**Re: Lot 6 Block 4 Unit 18 Volcano Cliffs, S.A.D. 228  
6600 Papagayo NW  
Request for Permanent C.O. – Not Accepted  
Engineer's Stamp dated: 1-2-18 (D10D003J6)  
Certification dated: 1/23/19**

CERTIFICATION FOR CO 1-23-19  
G&D UPDATE AND CO 1-31-19

LOT 6, BLOCK 4, UNIT 18  
VOLCANO CLIFFS SUBDIVISION

PECK (BUILDER: MICHAEL SANCHEZ) — GRADING & DRAINAGE PLAN

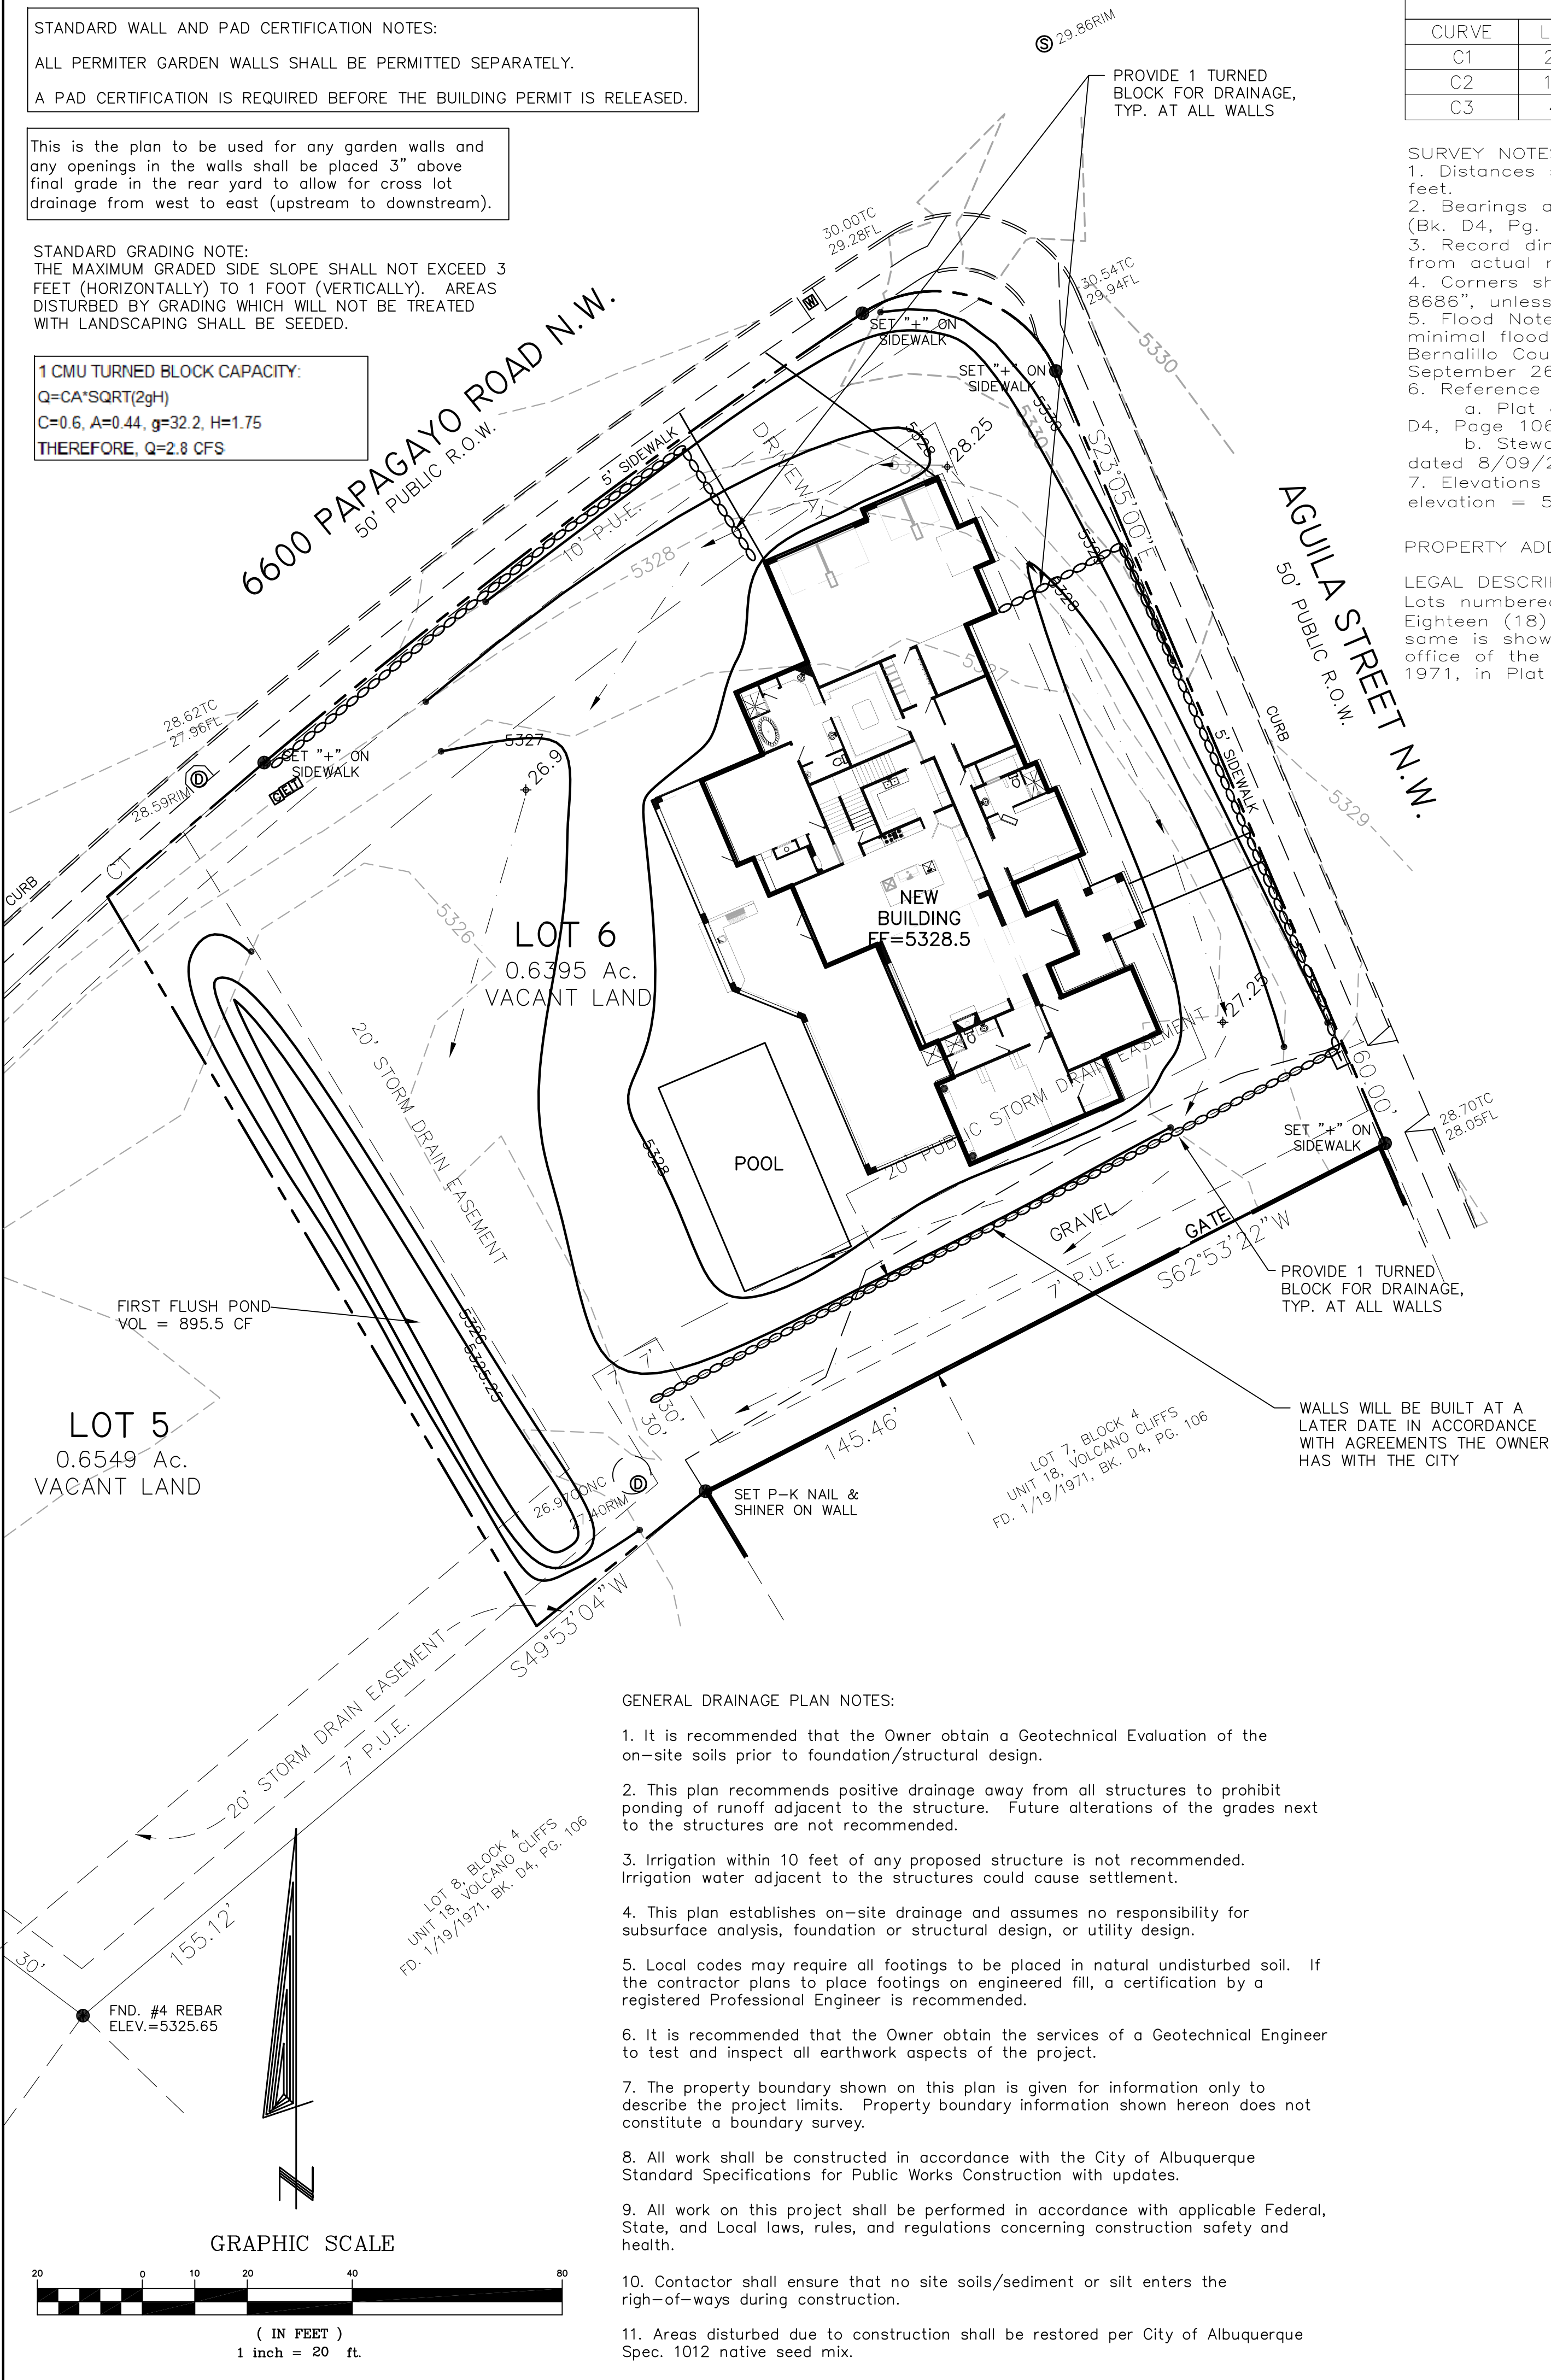
- Provide the new plat for this address, it appears that the lot line was moved.
- Provide the location of the 20' SD easement, one of the hatched lines are missing.
- Provide the new calculations including the pool area. Treatment D should have increase along with the ponding area.

- This site is not ready for C.O. **Noted.**
- Remove the all dirt and debris in and around this site. **Completed**
- Provide a new G&D plan to include the swimming pool. **Attached**
- Provide a new pond and calculations, the swimming pool was placed partially in the ponding area. **Included with updated G&D attached.**

ZONE 1  
UPDATED CALCS FOR UPDATED PROPERTY AND POOL
